## HIGHLAND COUNCIL

**Report Title:** 23/02462/S36: Loch Liath Wind Farm Limited  
Land 9000M SW Of Glenurquhart High School  
Balmacaan Road,Drumnadrochit

**Report By:** Area Planning Manager – South

Figure 4.1a: Site Layout

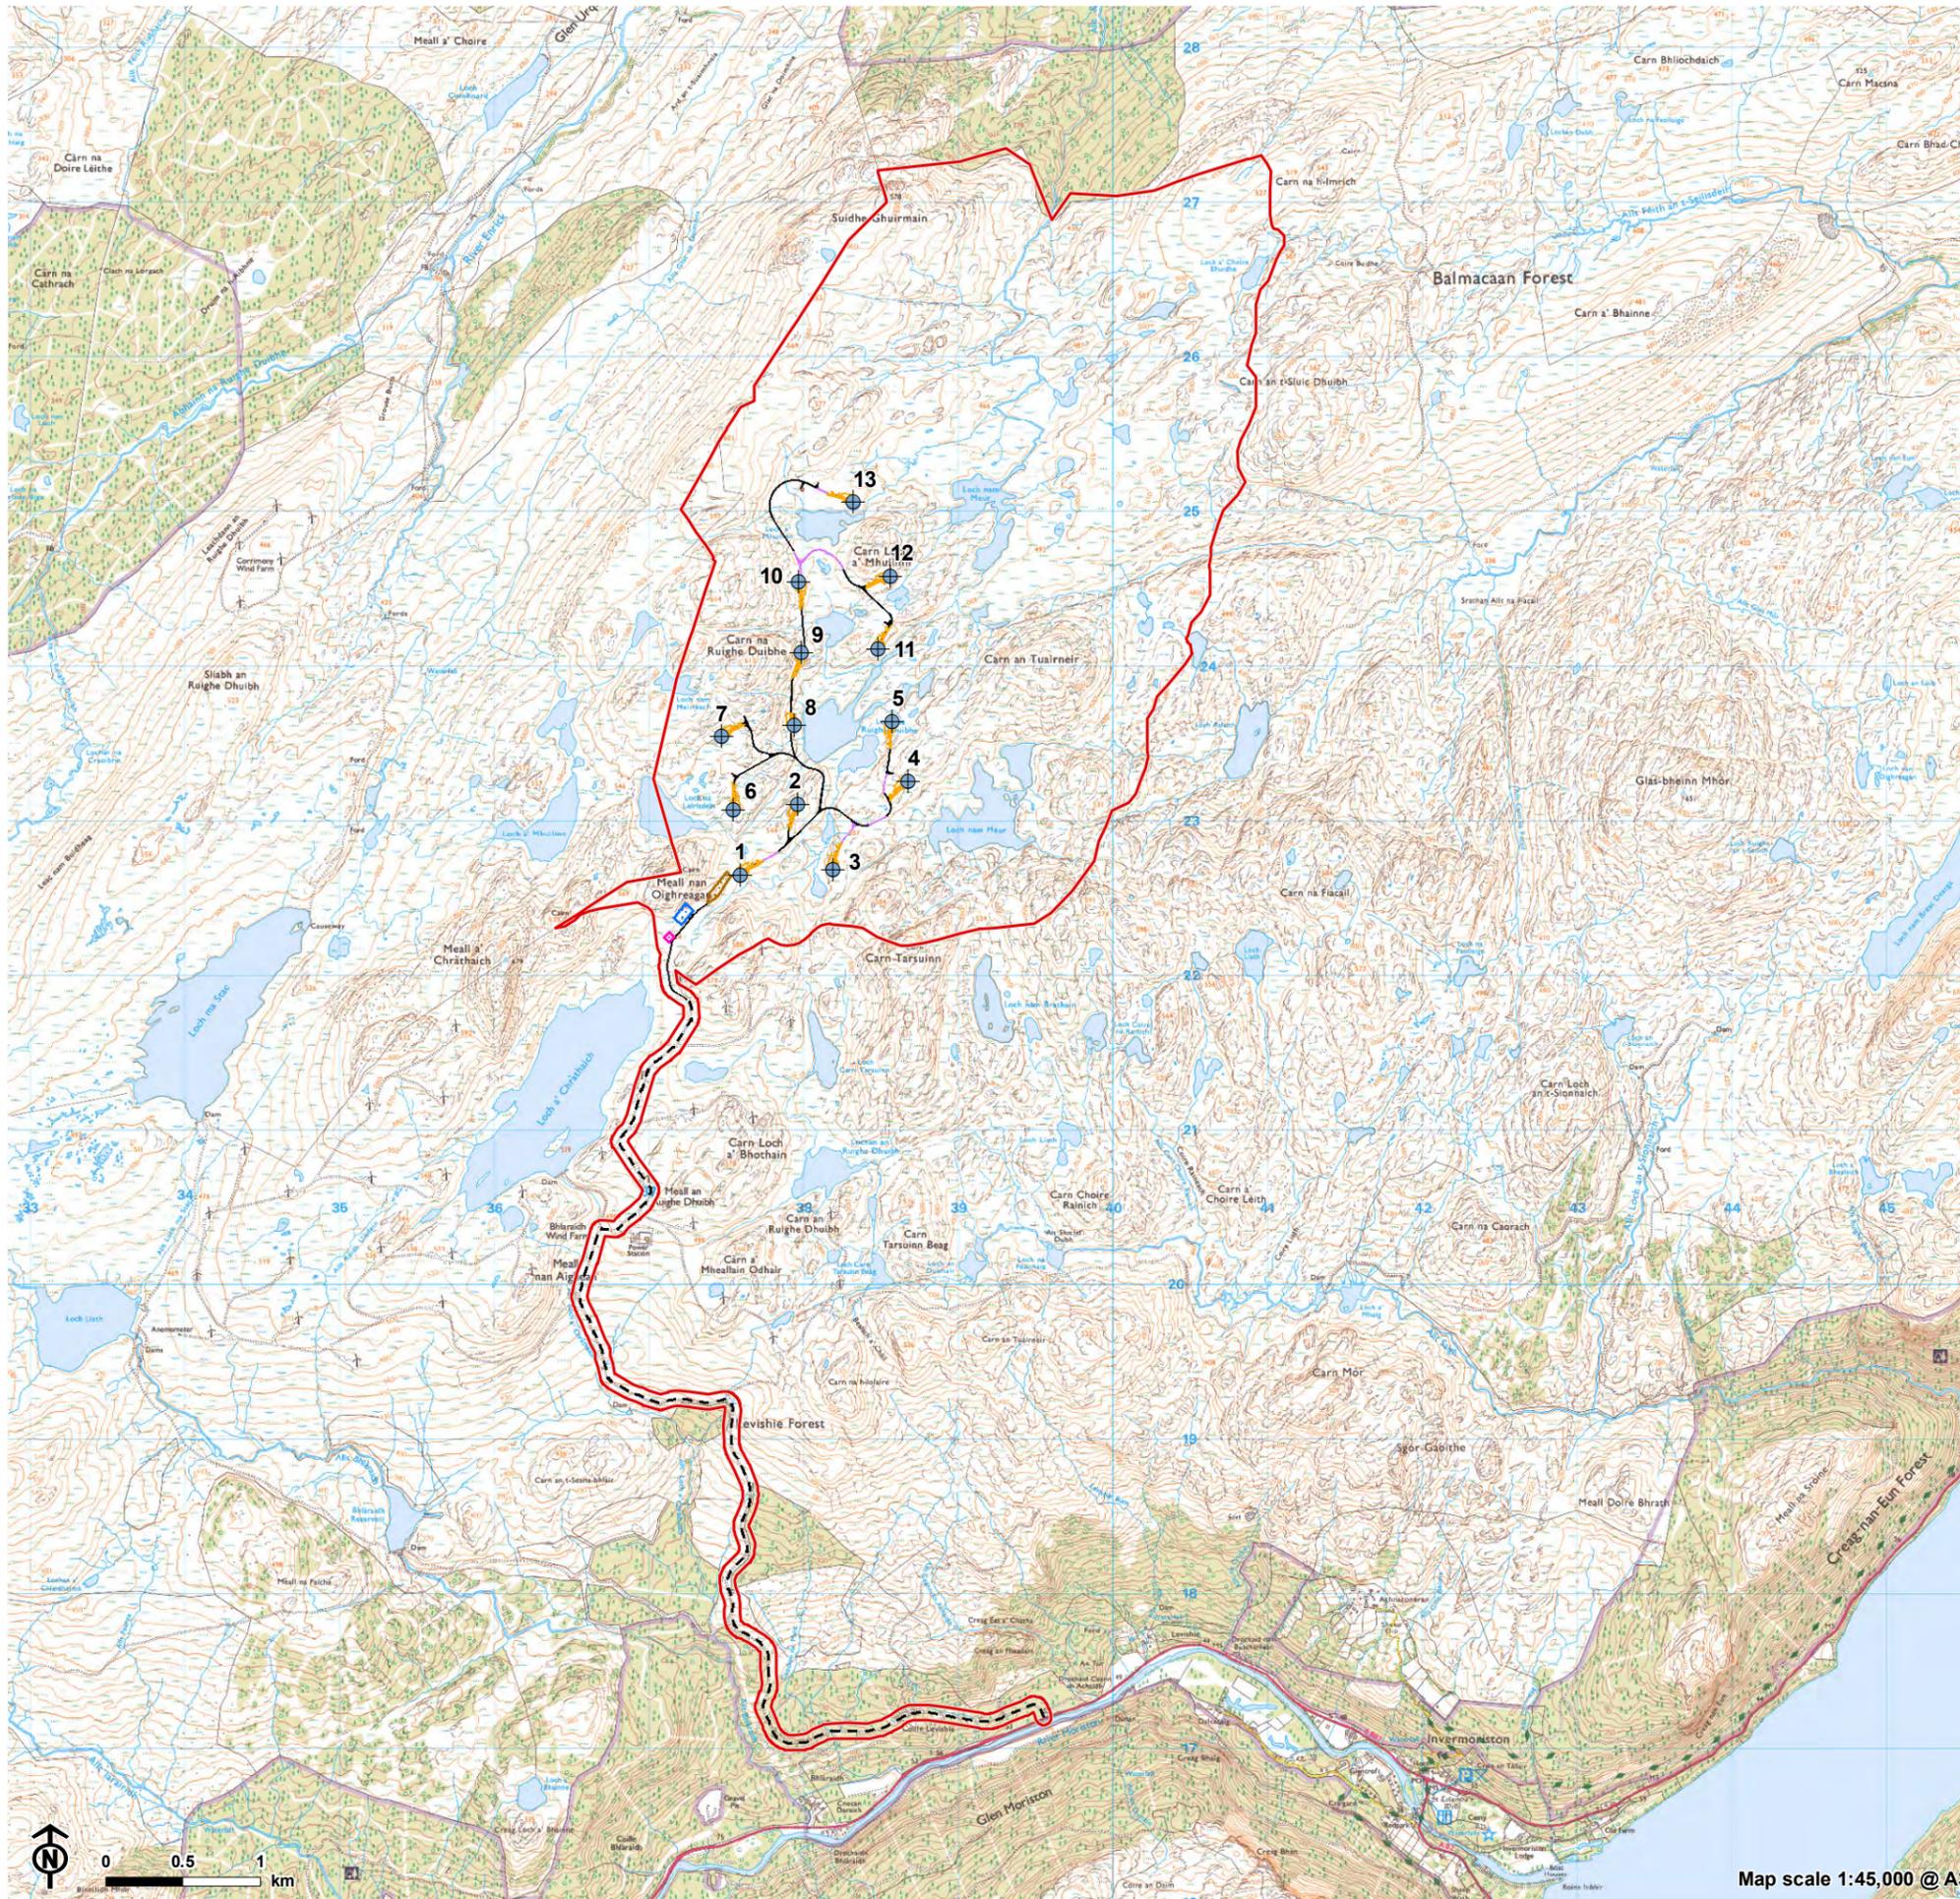
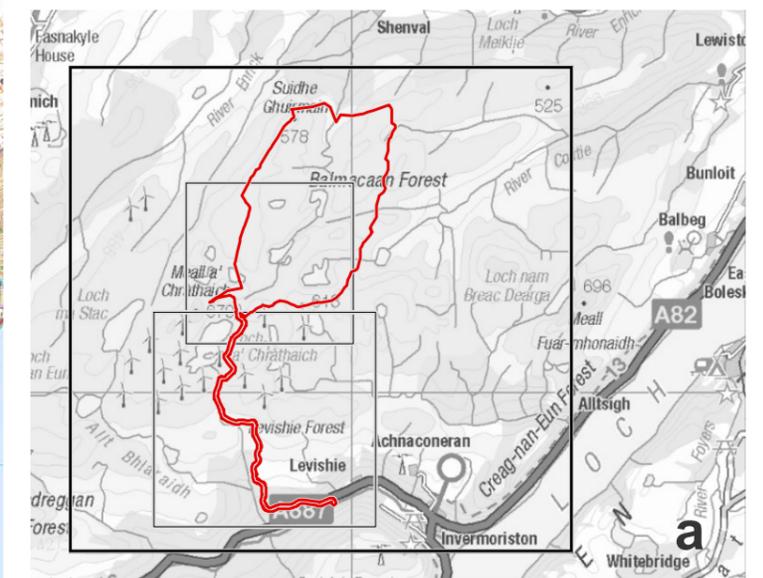
- 5.29 **SEPA** do not object to the application. It requests conditions to secure: a finalised Peat Management Plan; no micro-siting to place infrastructure on areas of deeper peat; the use of floating access tracks as per EIAR Figure 4.1; a finalised Restoration and Enhancement Plan; design specifications for the watercourse crossings; restoration of the borrow pit post construction; a finalised Decommissioning and Restoration Plan; and adherence to the Outline Construction and Environmental Management Plan and the Schedule of Good Practice and Mitigation Measures. In response to the SEI, SEPA have no additional comments to make but request a slightly updated wording of conditions, to reflect their developing approach to peat and peatlands.

- 7.132 The new access tracks will be constructed using both cut and fill and floating designs to limit impacts on deep peat. SEPA are content and require tracks to be floated as shown on EIAR Figure 4.1 and for this to be secured by condition. SEPA also require the finalised Peat Management Plan to demonstrate how micro-siting and other measures have been used to further minimise peat disturbance. It also requests that there is a further investigation into opportunities to deliver greater peatland restoration. Revised peatland restoration areas and further information to address NatureScot's concerns has since been submitted. This is detailed further in the 'Natural Heritage' section of this report below.
